Access Compliance Report Public Rights-of-Way (Curb Ramps)

Main Street: PURDY_ST Cross Street: WASHINGTON_AVE Location: W

ADA ID: RPRK220203150153 Ramp Type: Type 4 - Parallel Initial Pass/Fail: Fail Overall Compliance: No Severity Score: 4

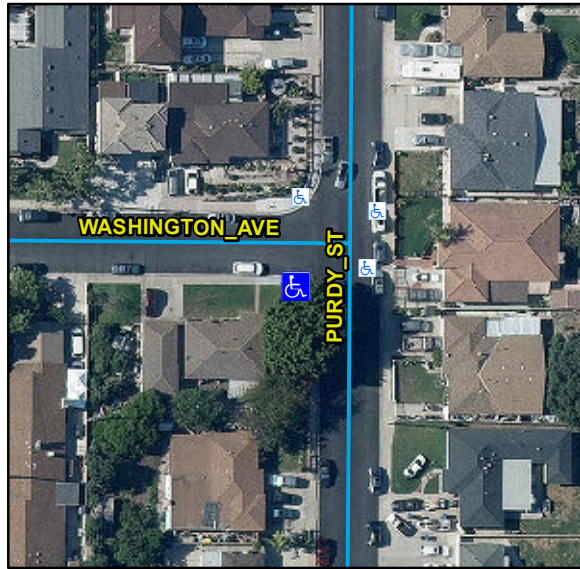
Compliance	Description	Data	Compliance	Description	Data
N/A	Ramp Length LT (in)	81	N/A	Ramp Length RT (in)	94
No	Ramp Width LT (in)	47	No	Ramp Width RT (in)	47
Yes	Ramp Run Slope LT (%)	7.7	Yes	Ramp Run Slope RT (%)	5
Yes	Ramp Cross Slope LT (%)	0.4	Yes	Ramp Cross Slope RT (%)	1.1
N/A	Landing Present	N/A	N/A	DWS Provided	N/A
N/A	Landing Length (in)	N/A	N/A	DWS Contrast	N/A
N/A	Landing Width (in)	N/A	N/A	DWS Length (in)	N/A
N/A	Landing Run Slope (%)	N/A	N/A	DWS Full Width	N/A
N/A	Landing Cross Slope (%)	N/A		DWS Offset Type	N/A
N/A	Landing Movement Obstructed?	N/A	N/A	DWS Offset Left (in)	N/A
	Landing Movement Type	N/A	N/A	DWS Offset Right (in)	N/A
N/A	Landing Shared	N/A			
N/A	Clear Space	Yes			
N/A	Clear Space To Crosswalk (in)	N/A			
N/A	Marked Crosswalk 1	No	N/A	Marked Crosswalk 2	No
	Crossing 1 Direction	E		Crossing 2 Direction	N
	Marked Crosswalk 1 Width (in)	N/A		Marked Crosswalk 2 Width (in)	N/A
N/A	Ramp Inside Crosswalk 1	N/A	N/A	Ramp Inside Crosswalk 2	N/A

Remove & Replace Curb Ramp With Two New Directional Ramps or Equivalent.

R304.5.1, STD 1115
